COMMUNITY DEVELOPMENT DEPARTMENT

Memorandum

Subject: PL-DR-23-0045 Sehmel Business Park, 5926 Sehmel Drive

Design Review Board Pre-Application Review

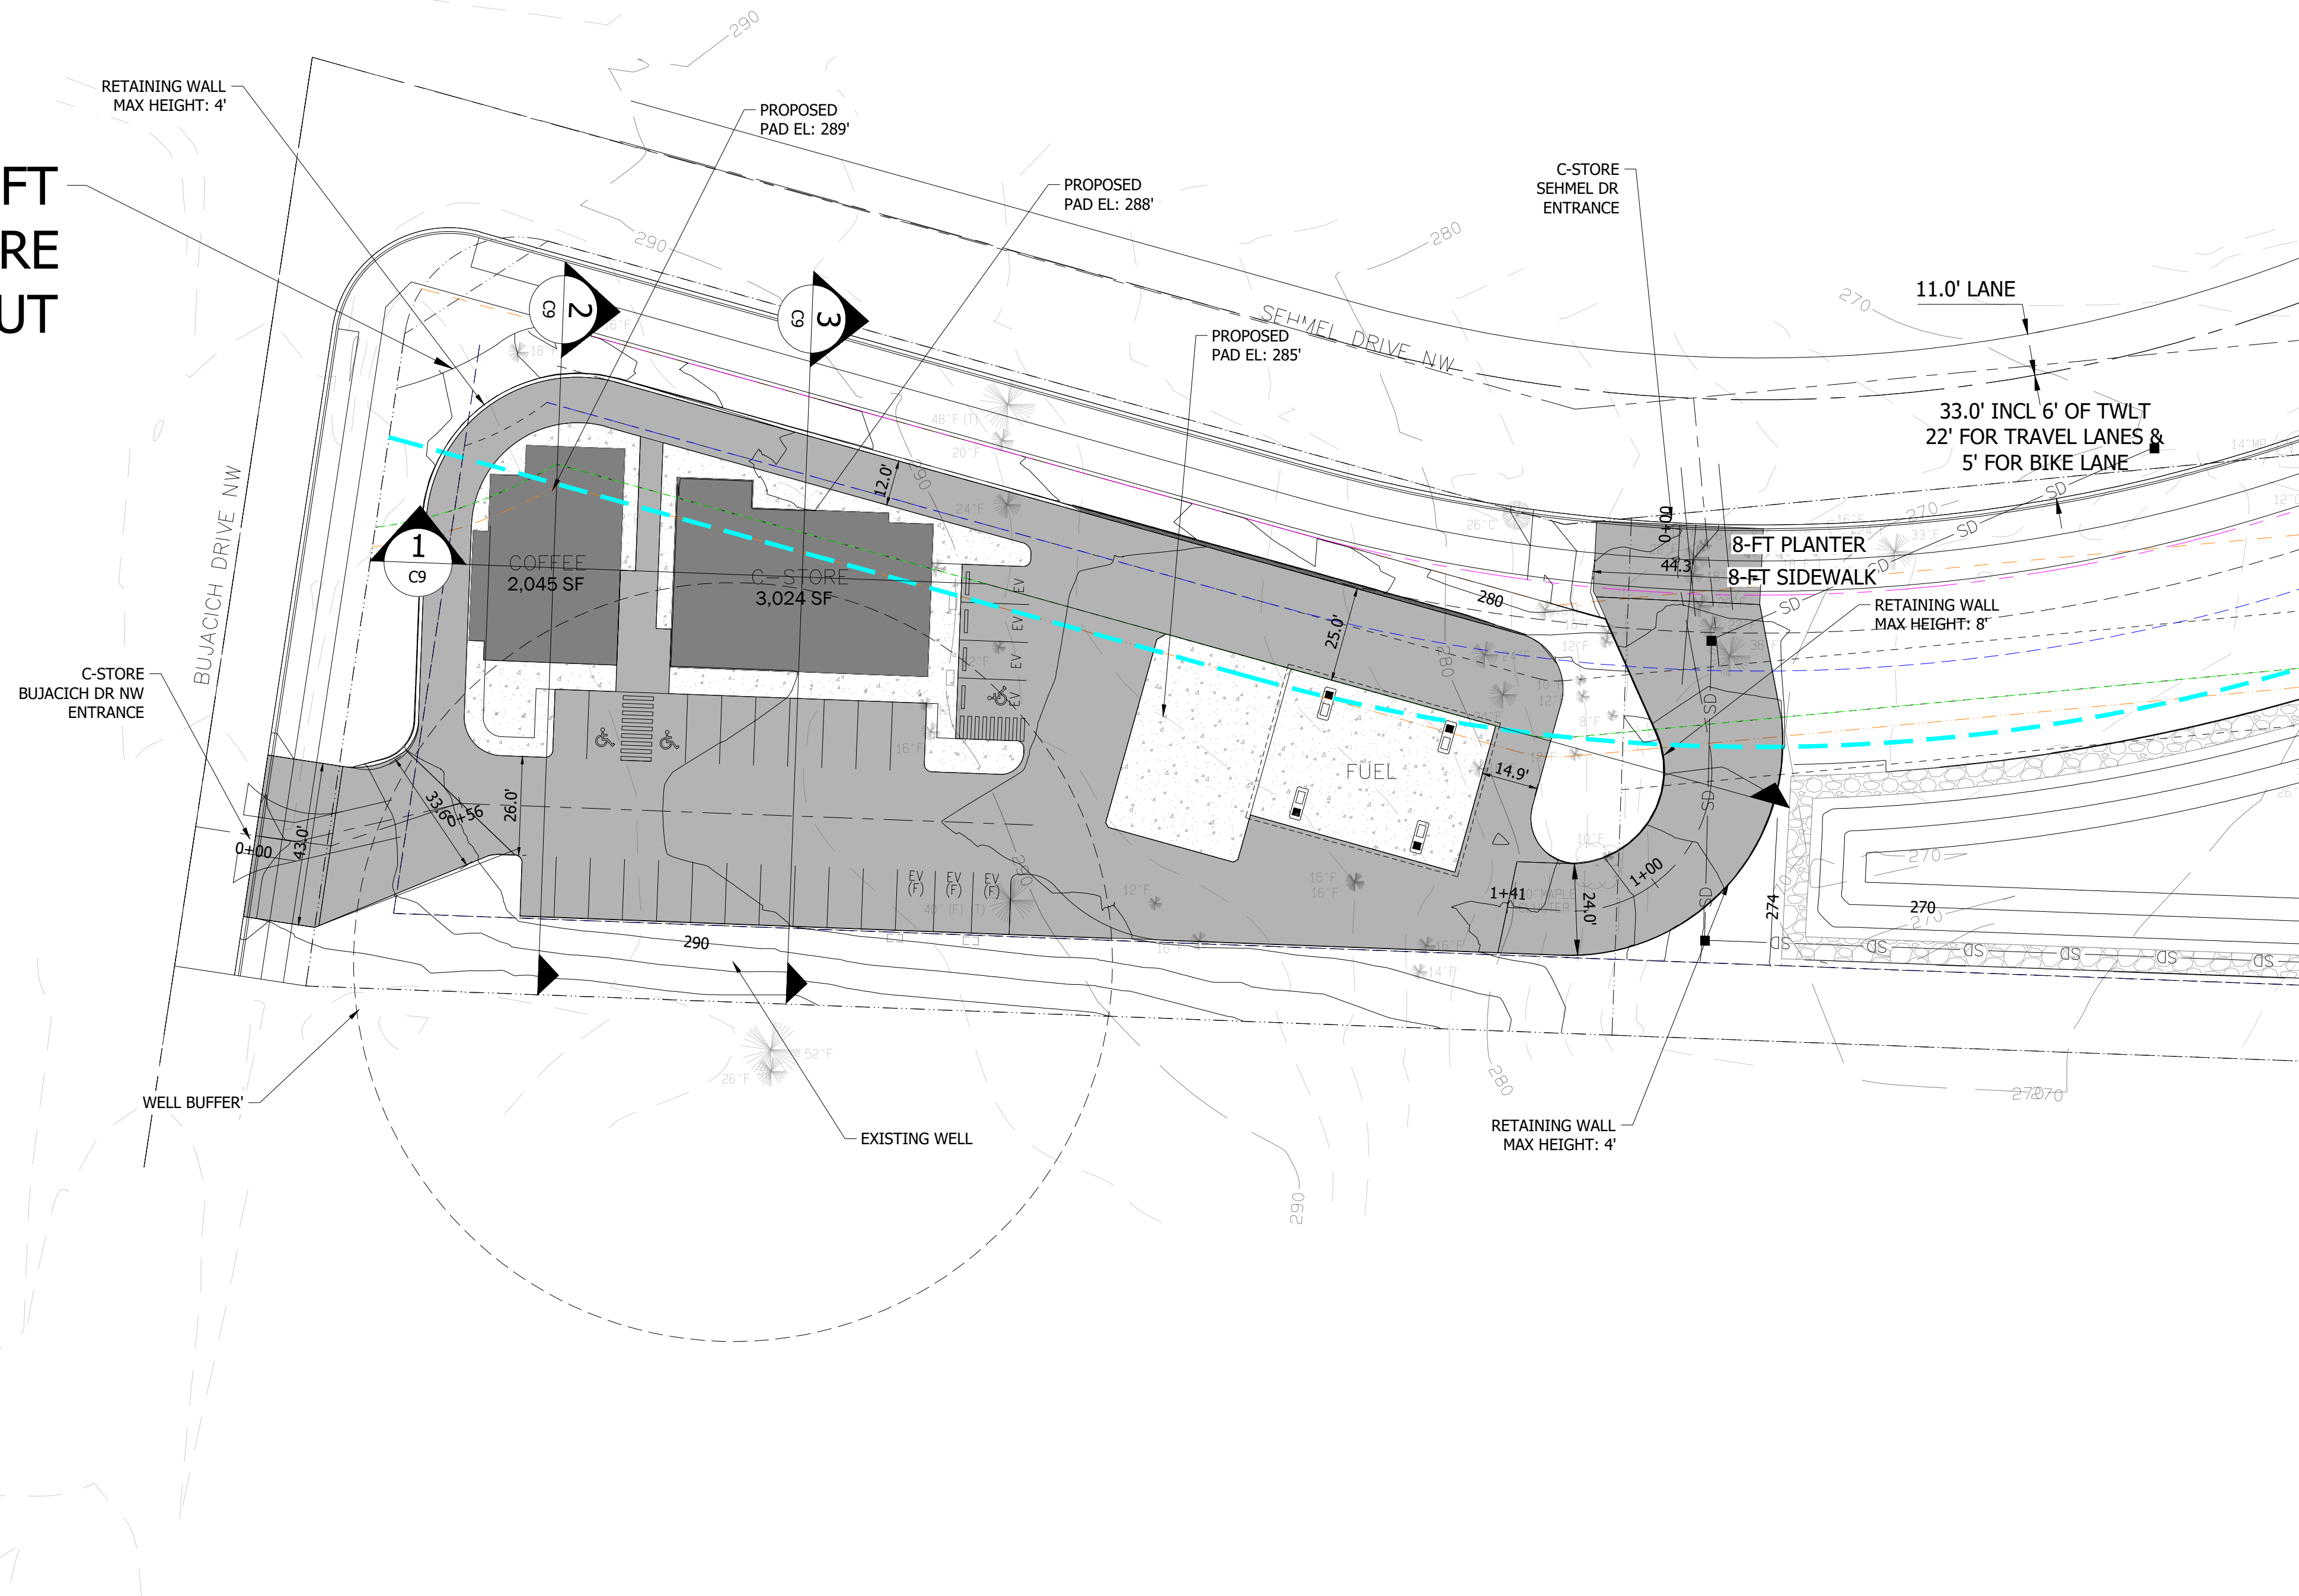
Staff Analysis: The subject site contains substantial grades and will need to create a grading plan with balanced cuts and fills, with retaining walls that do not exceed six feet. The city has used a standard of 10% as 'balanced' for prior projects. The proposed earthwork is as follows:

C-store earthwork
Cut: 6,334 cubic yards
Fill: 456 cubic yards
Excess cut: 5,877 cubic yards
